Subject: Contract No. 200-2004-03805, Task Order 1: *Paducah Gaseous Diffusion Plant Site Profile Review*, SCA-TR-TASK1-0016

Paducah Gaseous Diffusion Plant Site Profile Review

**Contract No. 200-2004-03805
Task Order No. 1
SCA-TR-TASK1-0016**

Figure 5.1-1. Schematic Drawing Showing Approximate Locations of PGDP Buildings
(Source: PACE/Utah 2000, Figure C-1)

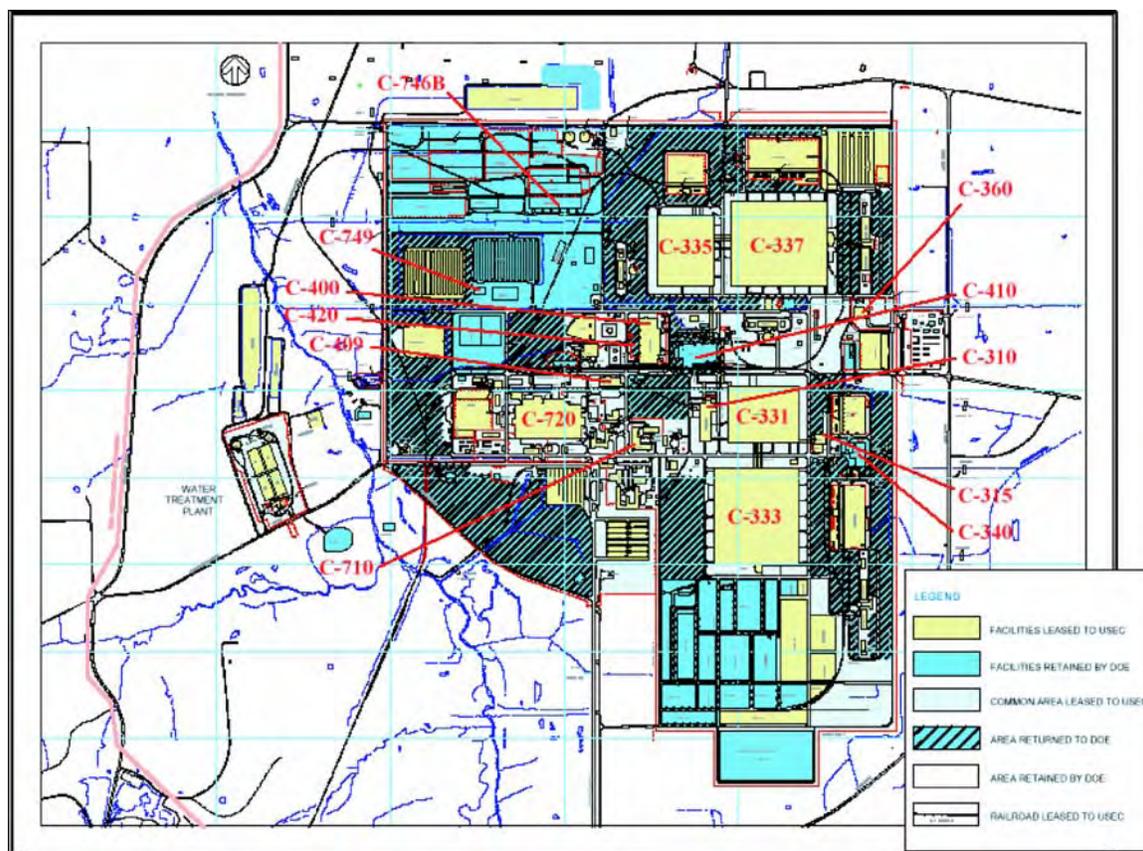
5.1.3 Issue 3: The Site Map in the TBD is Inadequate

The site description in Turpin (2006) provides very little information in terms of layout of process buildings, office buildings, storage and waste areas, holding ponds, etc. Unfortunately, the site map (Figure 2-2) is also uninformative. The PACE/Utah 2000 report site map (see Figure 5.1-1) shows the relative locations of the principal buildings and also identifies those that are currently leased to USEC. A good site map could provide the dose reconstructor with information such as the location of a worker relative to a nearby exposure source that might otherwise be overlooked.

EXHIBIT #1

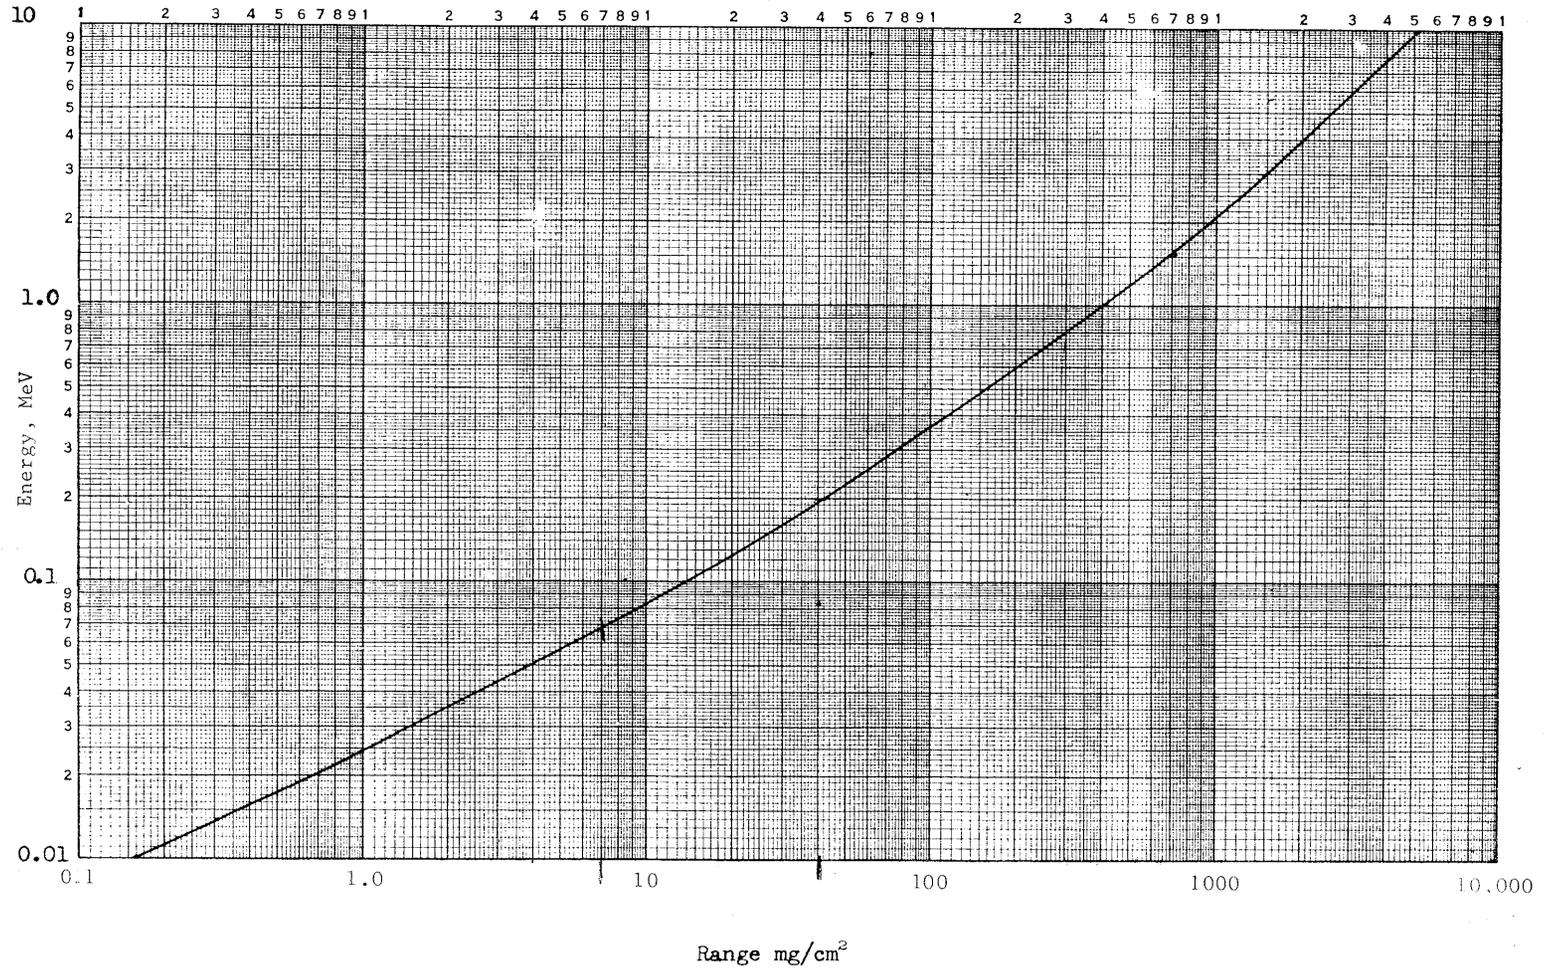
SC&A concludes that the combination of these factors is likely to have resulted in skin dose estimates that are inaccurate, low, and not claimant favorable.
